Westinghouse Electric Company
Nuclear Services
P.O. Box 355
Pittsburgh, Pennsylvania 15230-0355
USA

Your ref:
Our ref: LTR-NRC-02-60

Subject: Response to RAI on the "Topical Report on Modular Accident Analysis Program Version 5 (MAAP5) Pressurized Water Reactor (PWR) Large Dry Containment Model," WCAP-15844

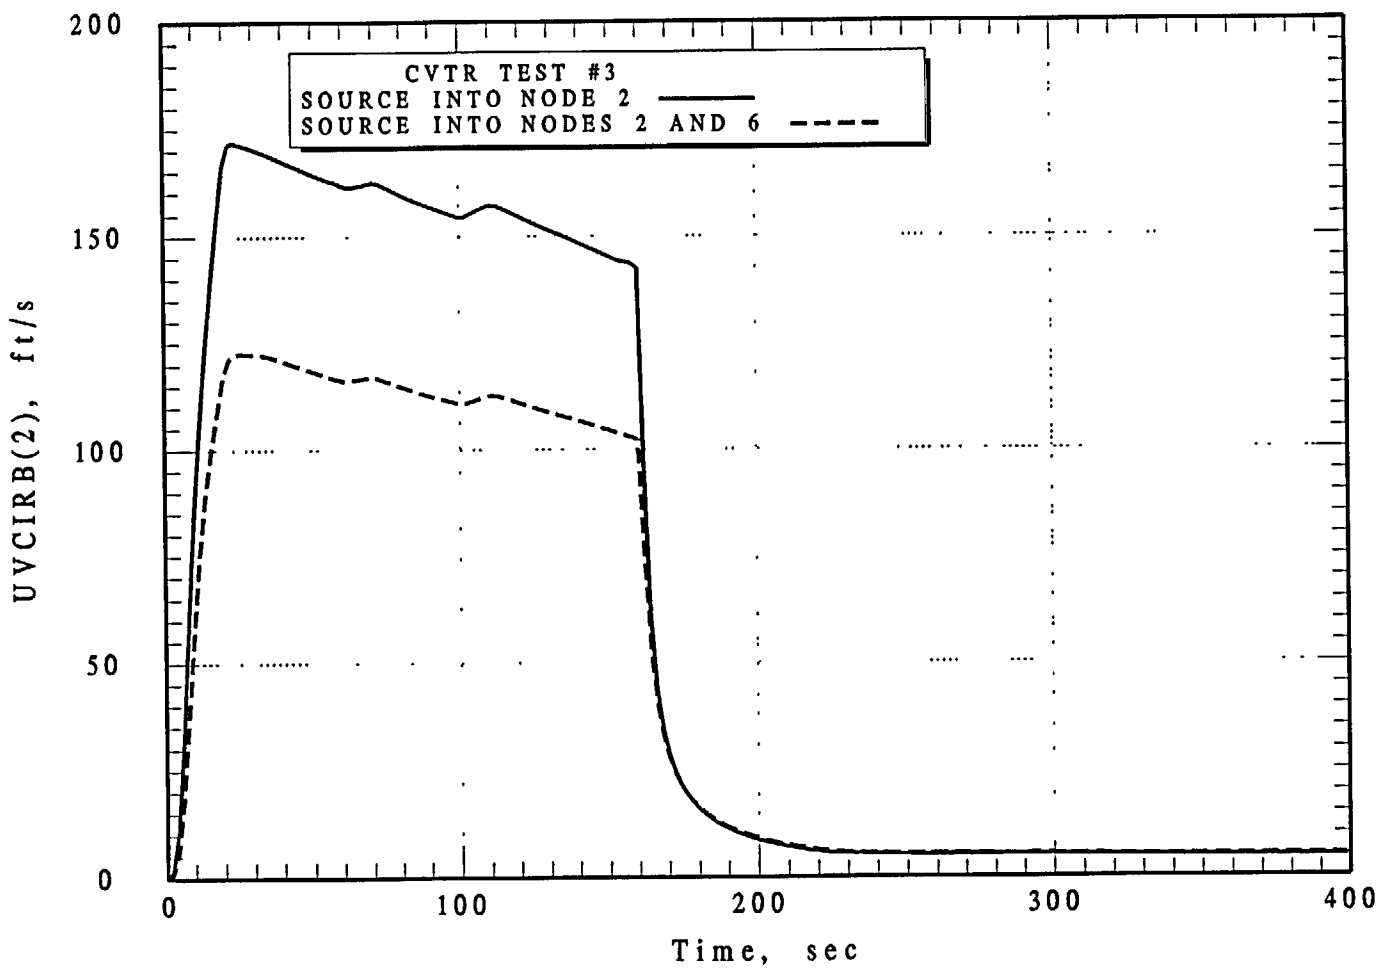
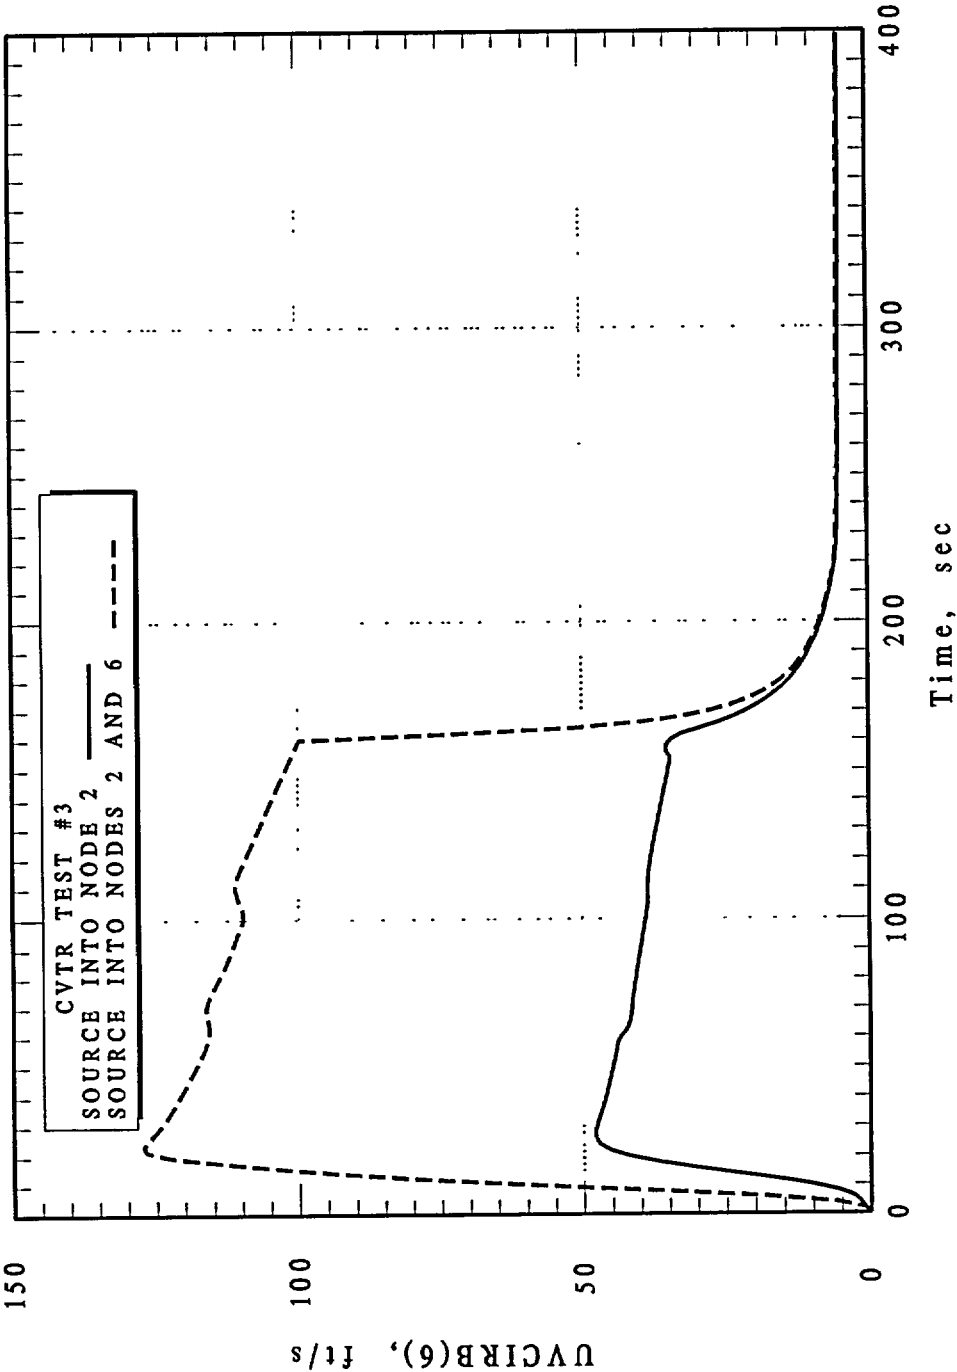
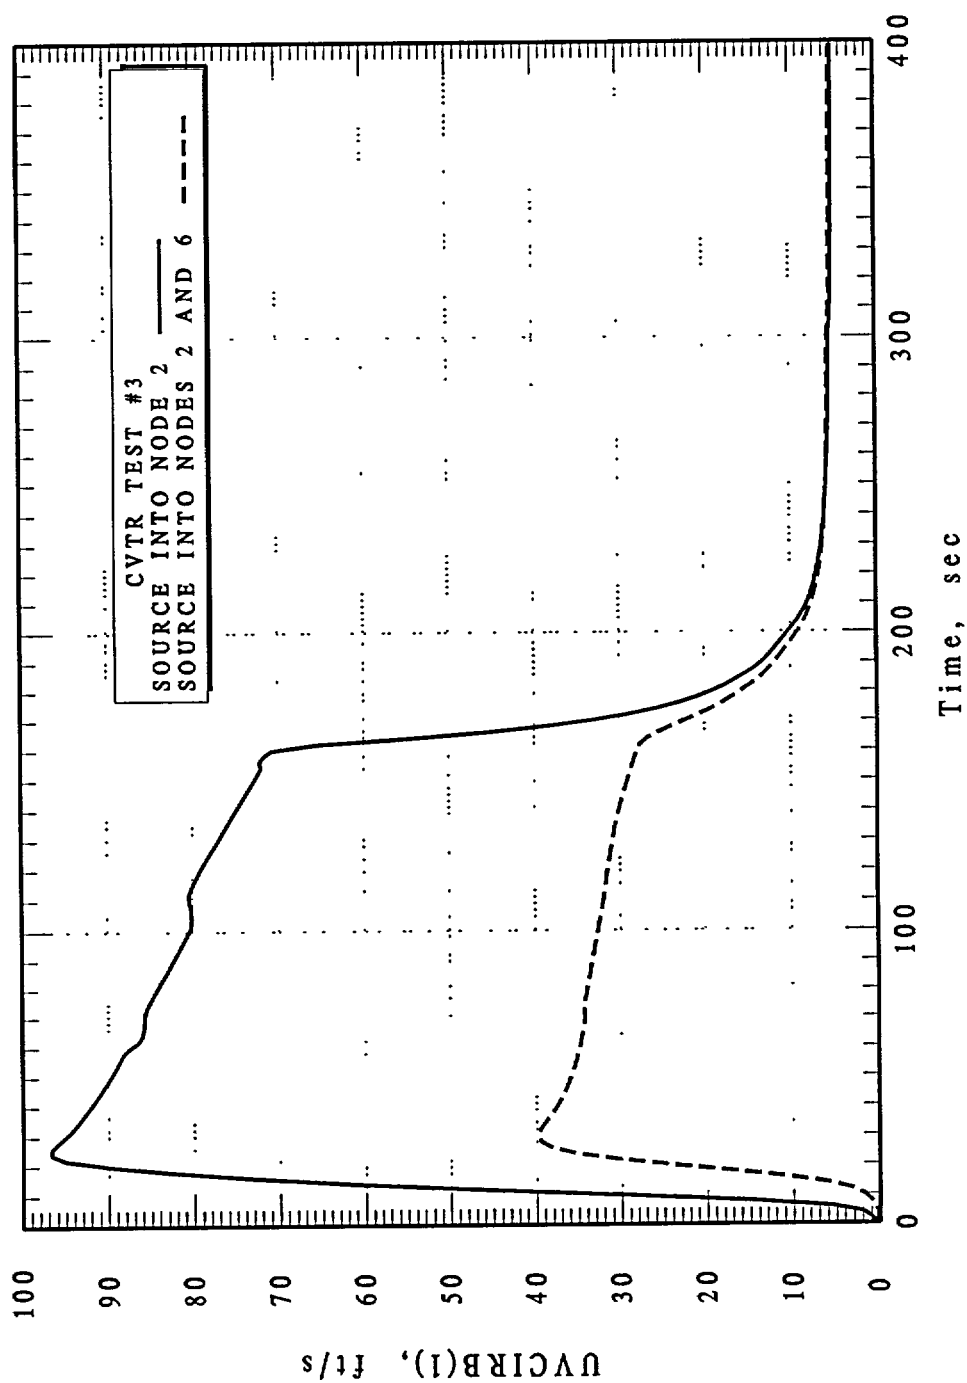
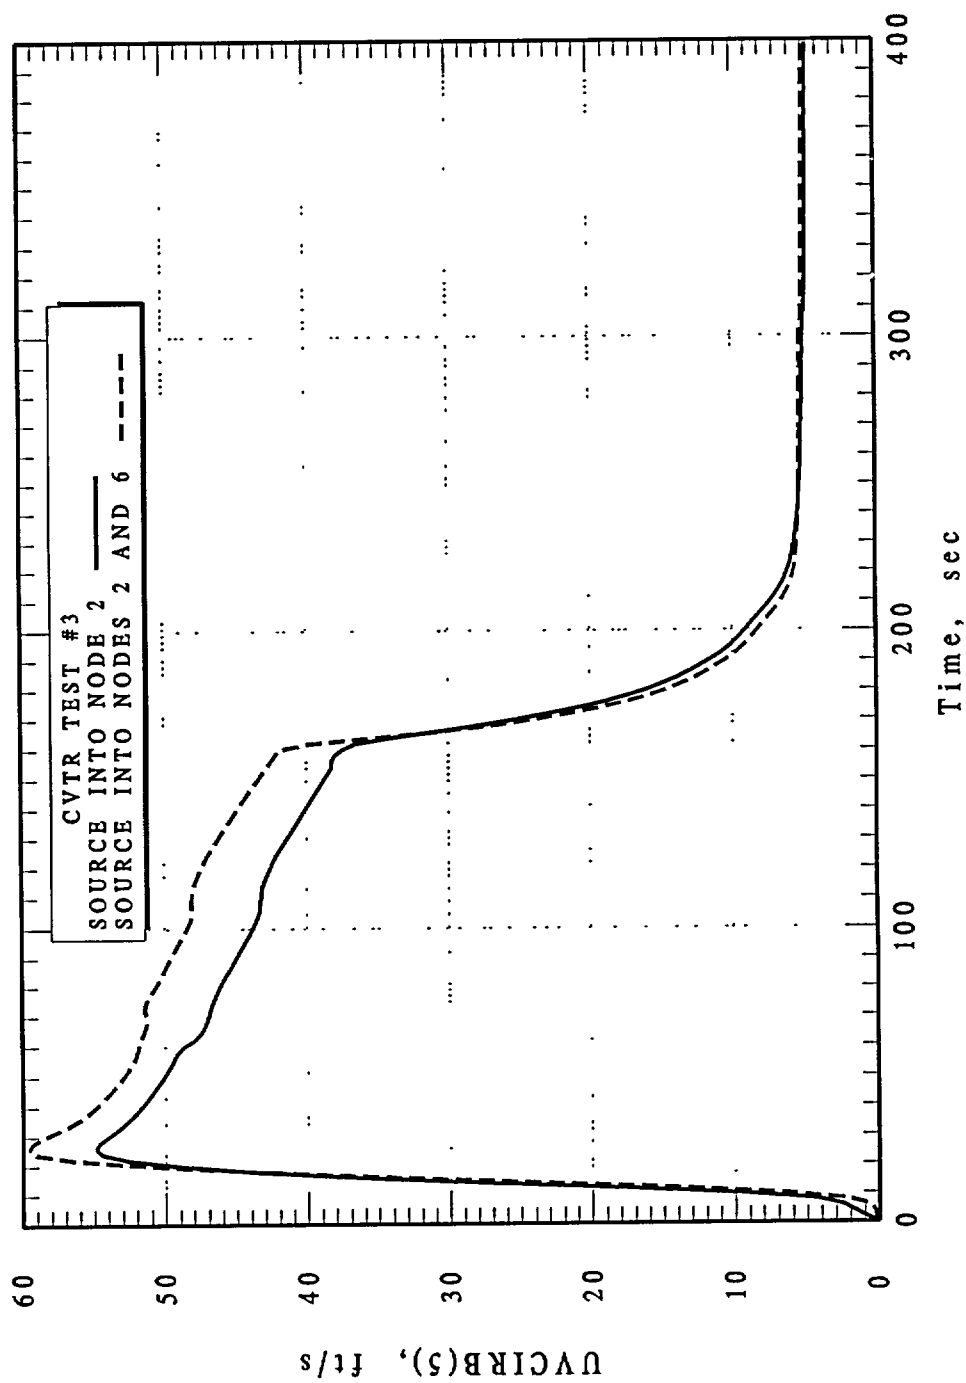
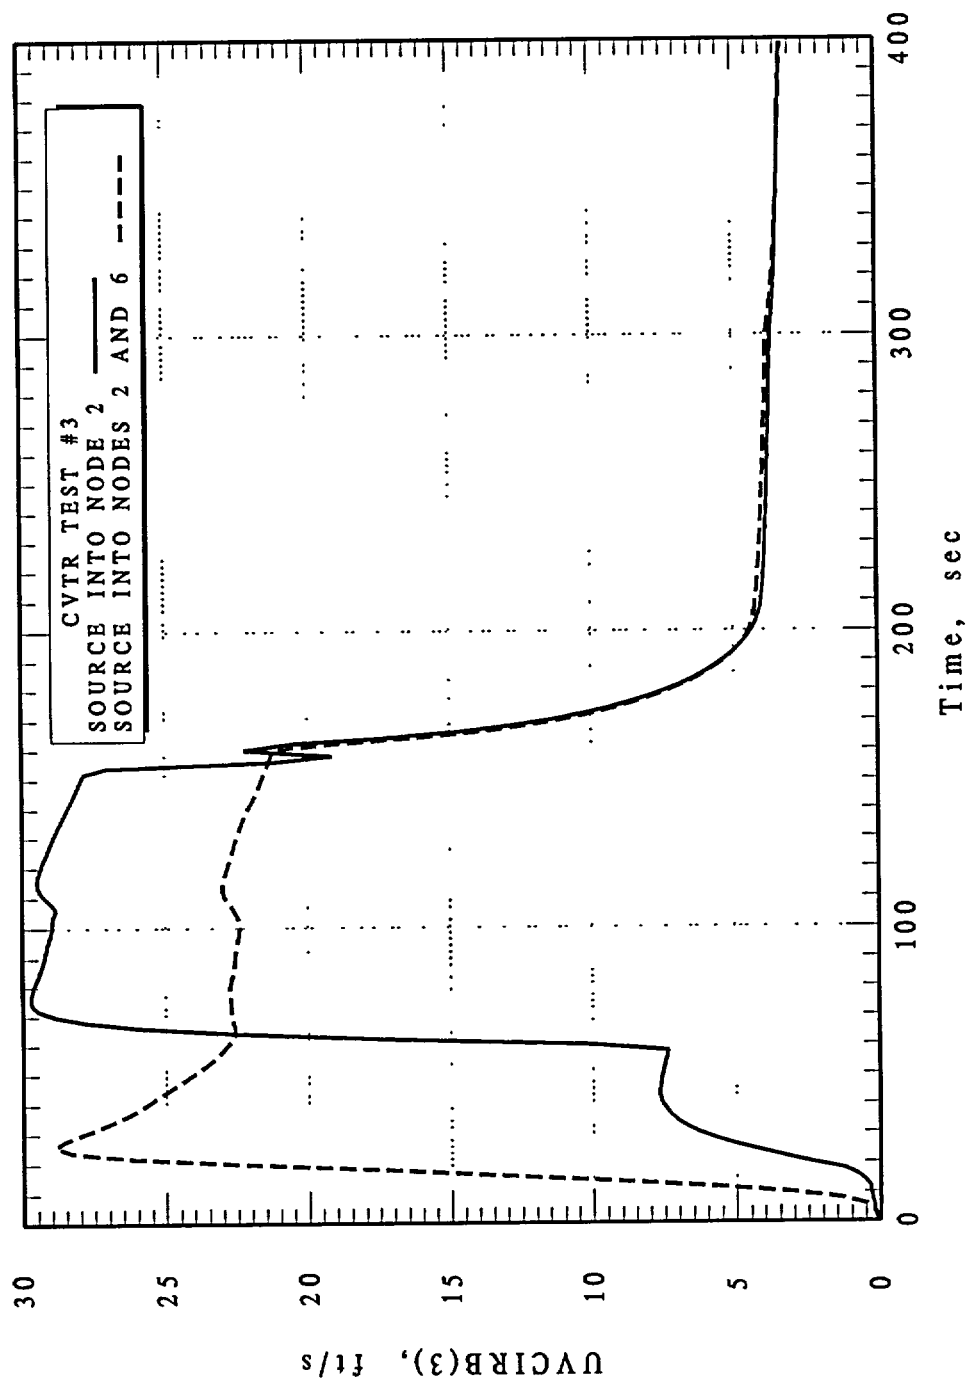
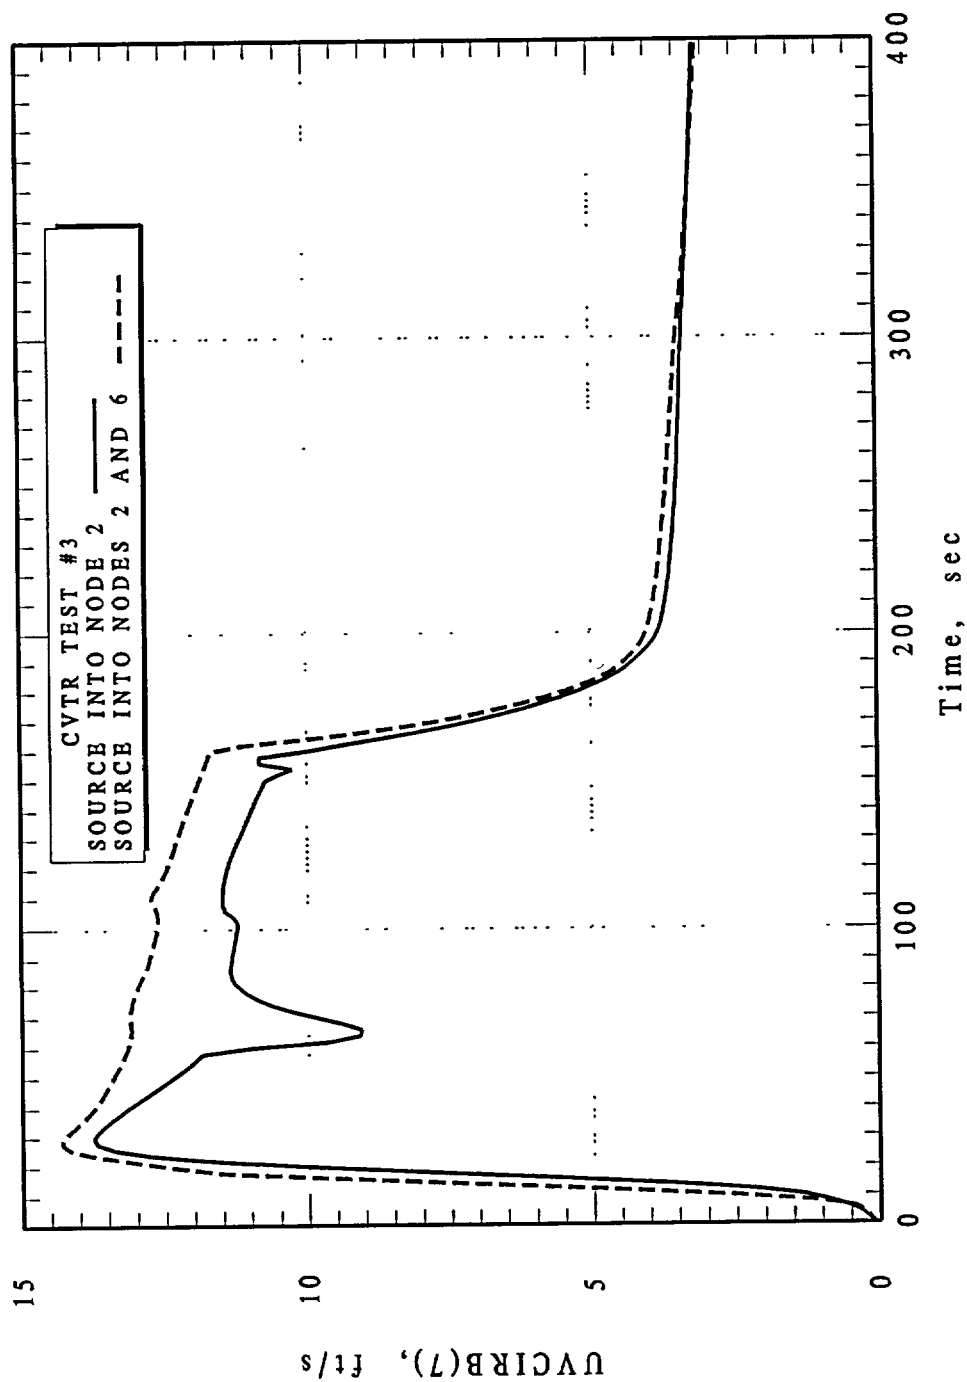
Item 2.2.9. It appears that FAI is using the CVTR test#3 measured velocity as a partial validation of the □momentum-driven velocity□ model. However, measurements (both direct and indirect), as well as published CFD calculations for test #3, all indicate that the peak wall velocity is 5-6 times lower than calculated using MAAP. Further, the annular gap velocity calculated by MAAP is approximately twice the value reported in the CVTR final report. Please comment. What additional, direct validation of calculated momentum-driven velocity has been obtained (other than CVTR) through the 5SSTAR process?

As described in the CVTR experimental report, steam was introduced above the operating deck through a 10 inch diffuser pipe (numerous small holes) to discharge the steam in several directions. In the MAAP5 Topical Report CVTR has been analyzed assuming that the steam was discharged into a single node above the operating deck (node 2 of the 12 node MAAP5 containment model). Additionally, for the RAI responses the containment response has been analyzed assuming that the steam was discharged equally into nodes 2 and 6 (both nodes are immediately above the operating deck).

The MAAP5 calculated momentum driven velocities are illustrated for nodes 1, 2, 3 and 4 for the two different M&E assumptions. As illustrated in Figures 1 through 6, when the source is discharged only into node #2, that node and node #1 immediately have velocities significantly higher than those indicated by the ultrasonic anemometer in the annular gap (15 ft/sec) and near the bend line (30 ft/sec). When the mass and energy is assumed to be distributed between nodes 2 and 6, the velocity in the break nodes are approximately 3 times the reported velocity. However, those velocities in the nodes immediately above the break node(s), show velocities comparable to those in the CVTR experimental report. Also, it is to be noted that when the steam is injected only into node #2, the calculated velocity in node #6 is also comparable to that in the CVTR report. The results for nodes #3 and #7, which are immediately below the operating deck show calculated velocities comparable to those reported in the annular gap.

In summary, as anticipated, there are a spectrum of velocities calculated with those in the break node(s) being the maximum. However, velocities in the other nodes result in calculated values which are comparable to those given in the CVTR data report.
